NIT No.: IITI(MM)/ WE/6/6G/661/PKN/2017-2018

Pre-bid Report

Pre-bid queries and responses for "IITI(MM/ WE/6/6G/661/PKN/2017-2018"
dated 03/05/2018 for " Supply of "SPORTS LIGHTING SYSTEM FOR FOOTBALL GROUND"

FOOTBALL
GROUND

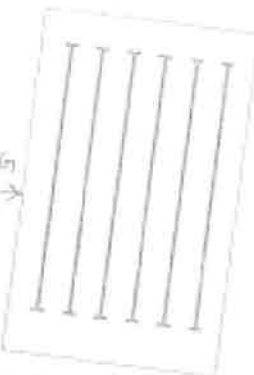
2.	Page 15, clause -4 Drawing		Kindly provide the layout drawing of football ground.	Attached	
3.	Page 12, Clause-3 Concessions		Please confirm if LED sports lighting will be exempted from custom duty. Please confirm. What is the concessional rate of GST applicable.	Custom duty exemption certificate will be issue with purchase order. Concessional Custom duty@5.15% will be applicable on all import. GST will applicable on actual rate.

27.		<p>To prepare lighting design, we need dimensions of stadium with preferred mast locations.</p> <p>Kindly provide the layout drawing (in Auto cad format) of the ground showing the football field, (athletic field – if it is there), swimming pool, surrounding road / pathway, all adjacent boundary wall , rain water drainage line, substation/power source location etc. It is required to locate the mast, preparing the illumination design & electrical system & smooth execution of the projects as well.</p>	Attached

28.		<p>Is it only football ground or athletic track shall be there all around the football ground? Shall the mast be located just adjacent to the football field or outside the athletic track? – need complete layout drawing to decide the location of mast. Mast height shall be considered based on position of mast only (distance of mast from the longitudinal centre line / centre point of the football field).</p>	Football ground Only

30.		<p>Is there any spectators stand canopy / building to be constructed adjacent to the football field that may obstruct the FOP lighting? – if it is there, please share all obstruction details.</p>	Attached
